**Submission of Further Information**

**Temporary Warehouse (excluding Dangerous Goods Godown) with Ancillary Office  
for a Period of 3 Years**

**Lot 771 RP in D.D. 130, Lam Tei, Tuen Mun, New Territories**

**Plan 4.1  
( P25013 )**

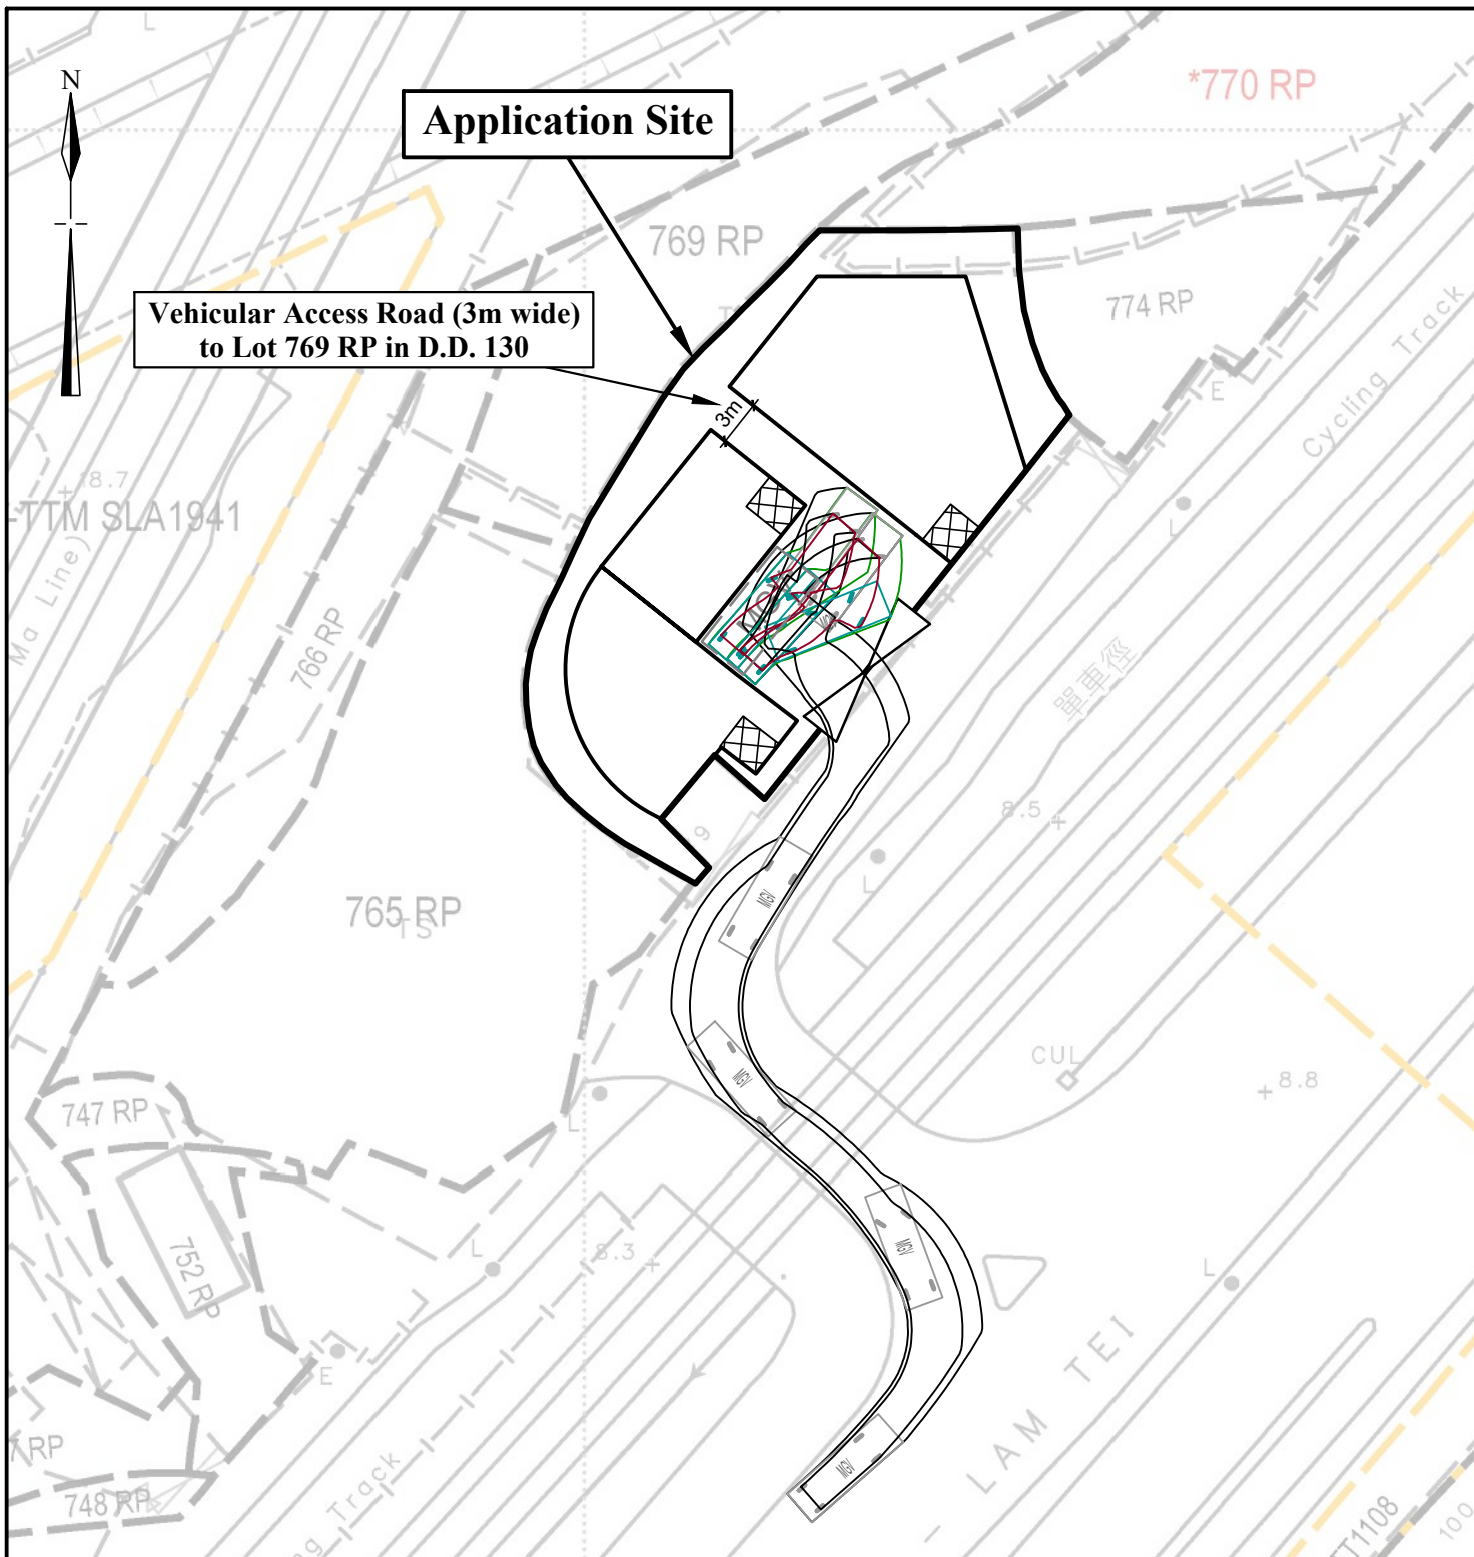
b.	It is noted that a new site entrance will be formed. Please clarify the width of the proposed site entrance.	The width of the proposed site entrance is 10m. Please refer to Swept Path Analysis (Plan 4.1 and Plan 4.2) for details.

c.	The vehicular access should be designed and constructed by the applicant in compliance with HyD's standard and to the satisfaction of HyD.	Noted.
d.	Please supplement the swept paths showing the proposed vehicles (i) entering the site from and leaving the site to the unnamed access road adjoining Castle Peak Road – Lam Tei via the site entrance; (ii) manoeuvring within the open area of the site; and (iii) entering and leaving the parking spaces.	Please refer to Swept Path Analysis (Plan 4.1 and Plan 4.2) for details.
